AS-BUILT SURVEY OF DAM#3

FORD'S COLONY AT WILLIAMSBURG

FORD'S COLONY
DAM SITE NO. 3
PLAN VIEW, PROFILE & CROSS SECTIONS
JAMES CITY COUNTY VIRGINIA

RE: Engineering Evaluation of Dam #3, receiving facility for SP-89-03, Ford's Colony Parking Lot Improvements AES Project No. 5652-33

DAM No. 3 PLAN
1"=20'

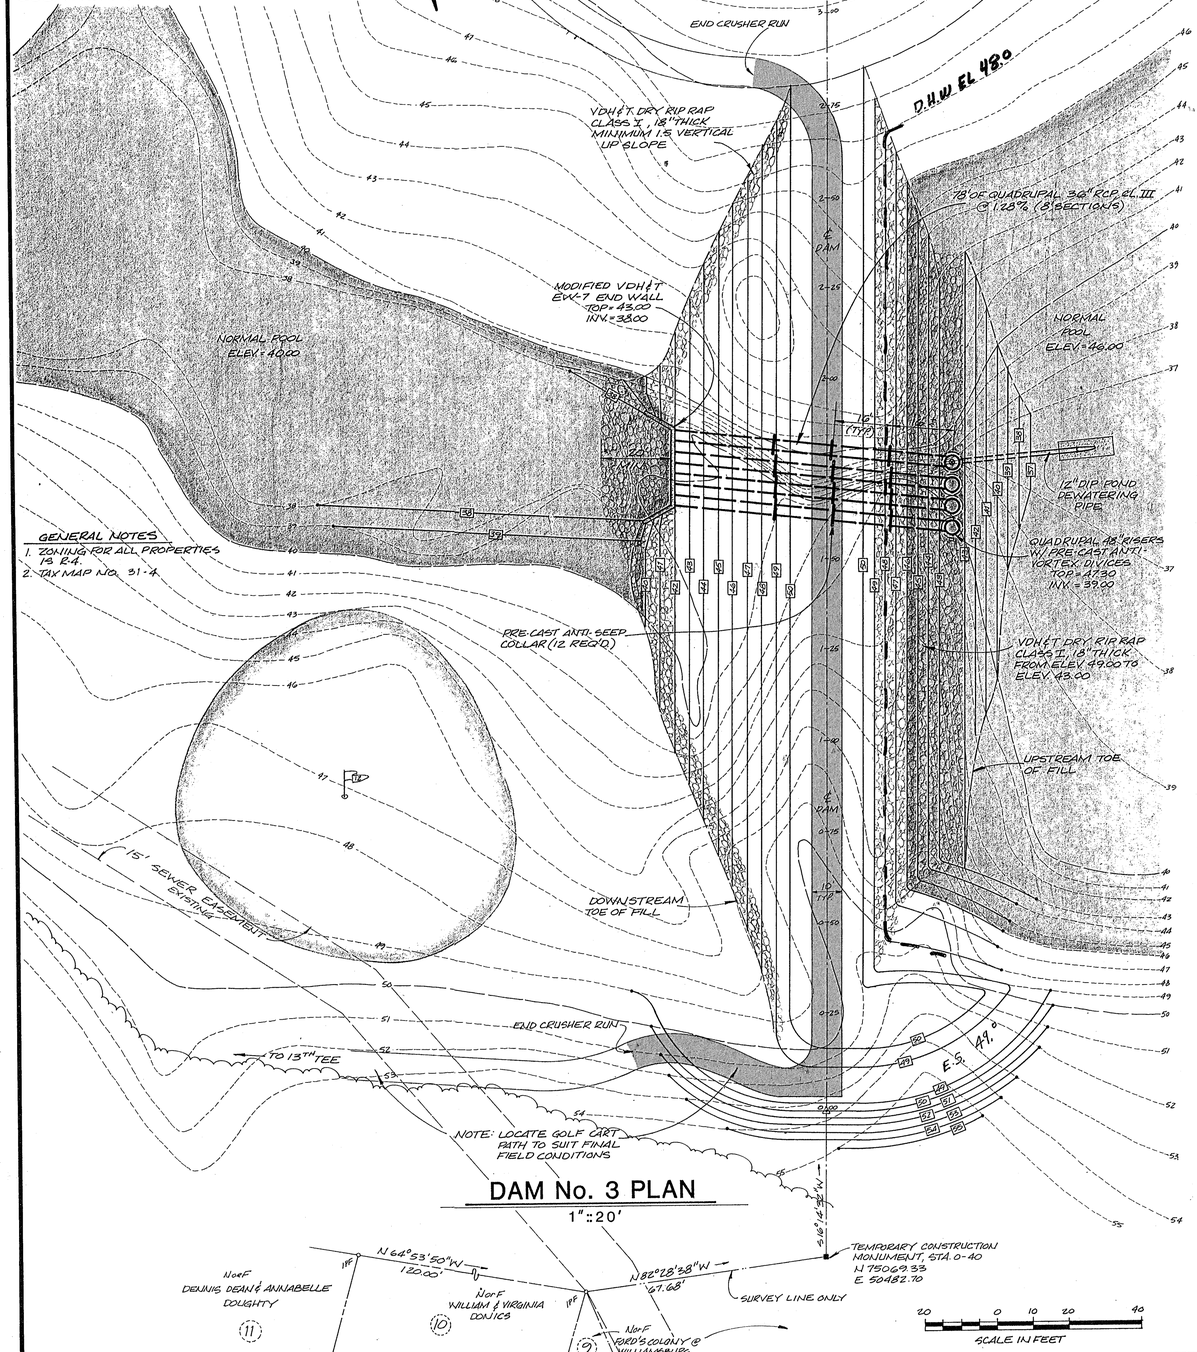
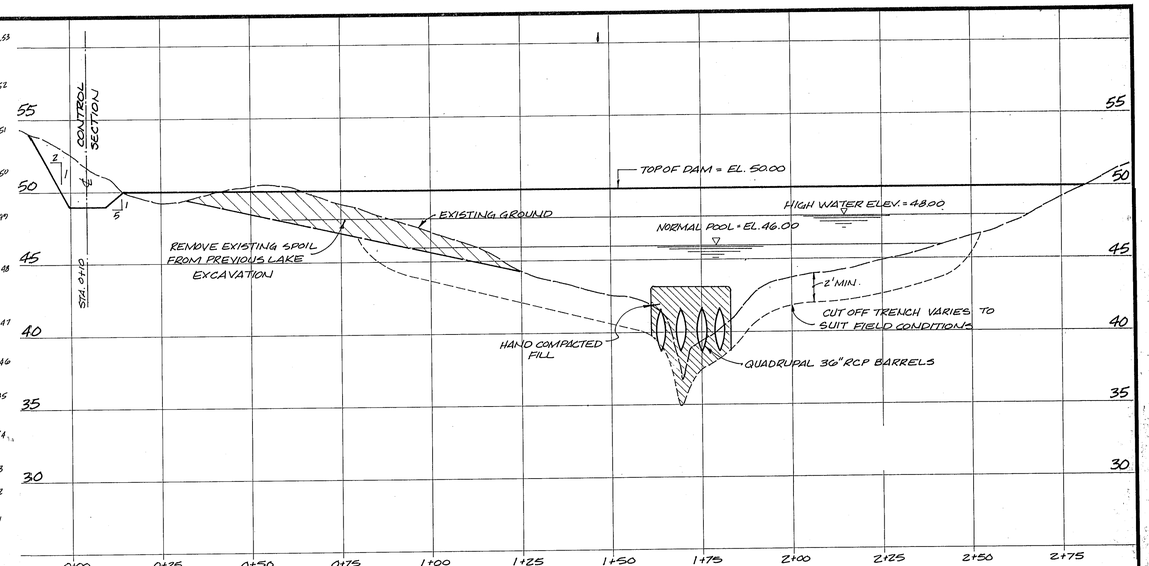
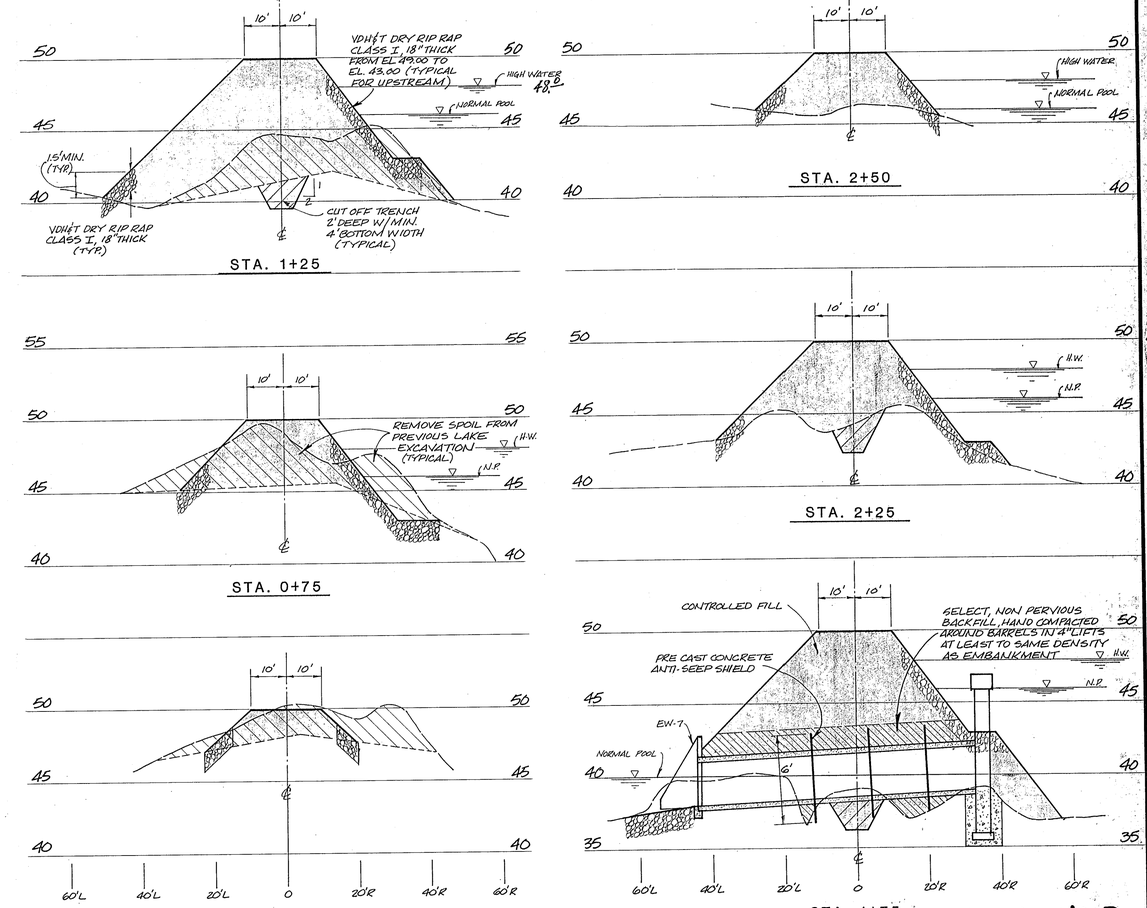
No.	DATE	REVISION / COMMENT / NOTE	BY
2	9/25/84	REVISED PER J.C.C. COMMENTS	DAR
1	9/6/84	REVISED PER SITE PLAN REQUIREMENTS	DAR

Reservoir No. 2 - Dam 3 (revised)

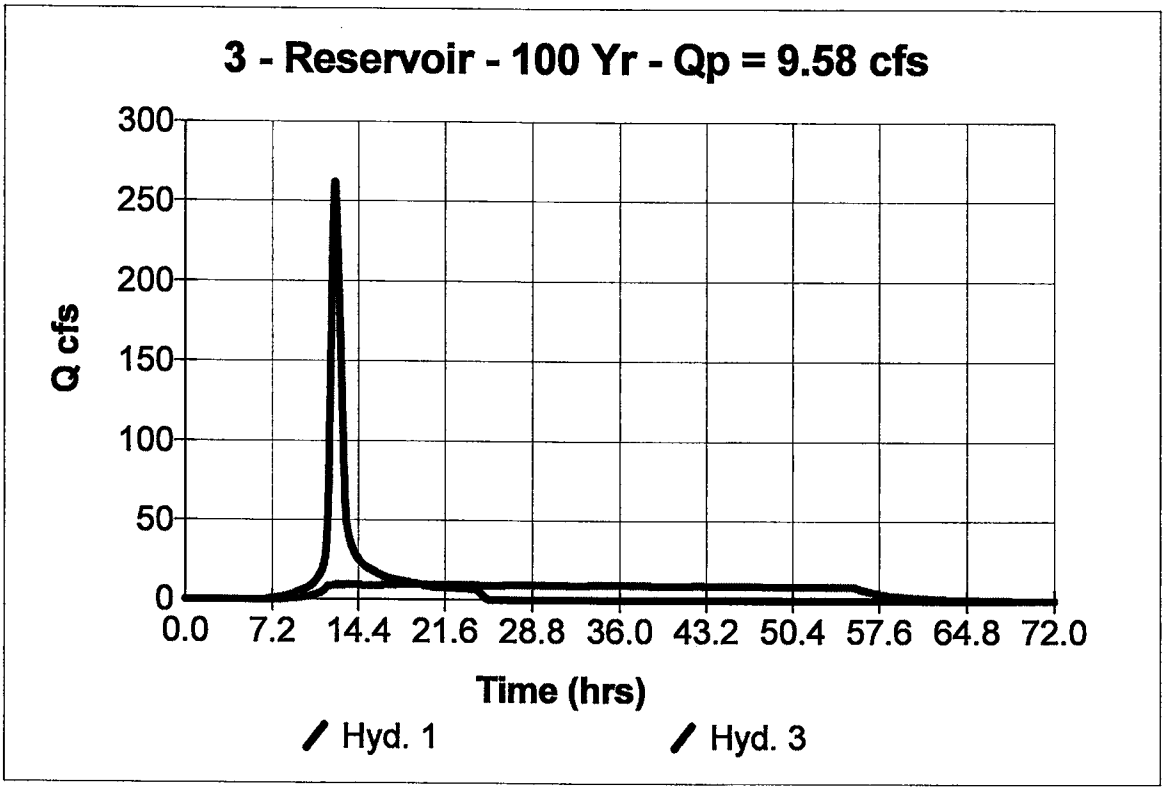
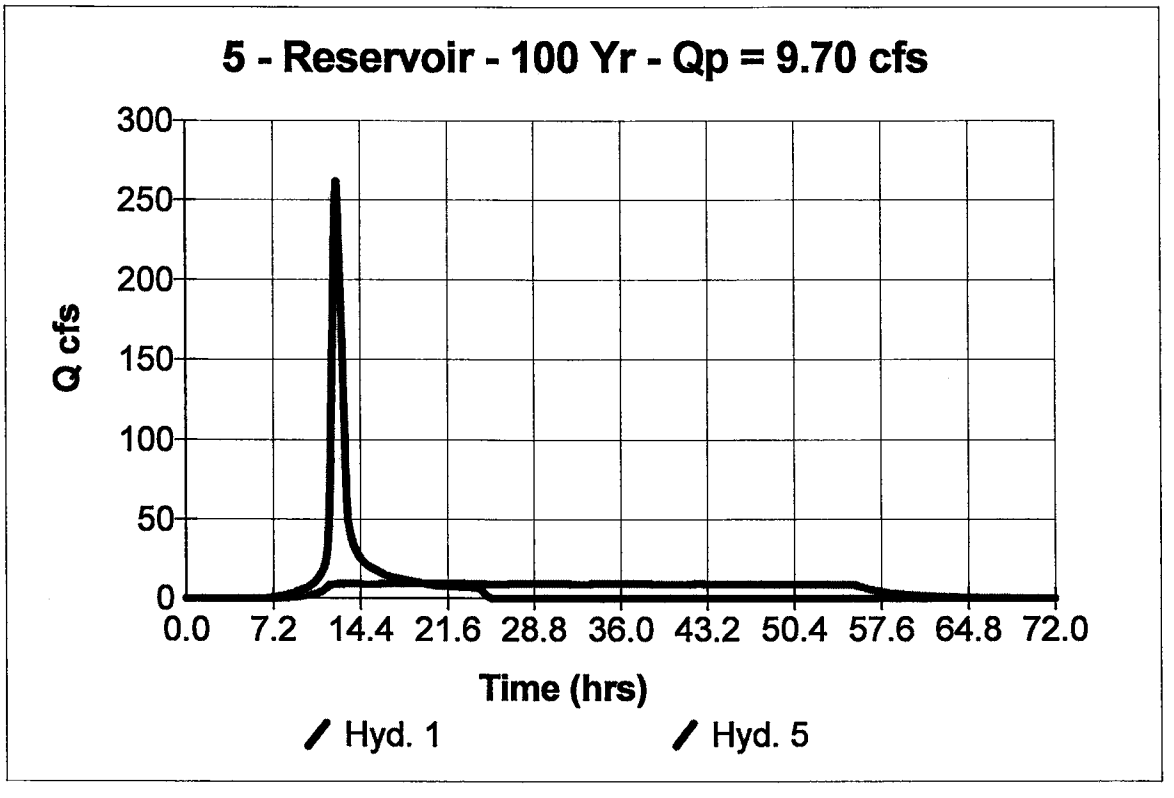
AES Consulting Engineers is submitting an analysis of the 100-year water surface elevation (WSEL) of the pond known as, Dam 3, in Ford's Colony Section XIII-A. The revisions are required because of the proposed grading activities on Lot 35, Section 13-A of Ford's Colony, which lessens the volume of Dam 3.

To provide a baseline, AES researched the design files and identified the 100-year WSEL to be 49.93 ft (occurring at the 50 contour on mapping associated with the area). According to the current development plan, the grading for the lot will result in altering down to the 48 contour. Our calculations show that the total net loss in volume due to the planned impact will be approximately 10,575 cu. ft., which translates to a change of less than a tenth of a percent in the total storage volume of the pond. The change in the WSEL due to the 100-year storm is negligible (less than a tenth of a foot).

It is our judgment that the grading activities will not have any effects, adverse or otherwise on the area surrounding the pond. We are providing a copy of the previous calculations, as well as the revised calculations for your review. Please feel free to call if you have any questions or concerns regarding this project.
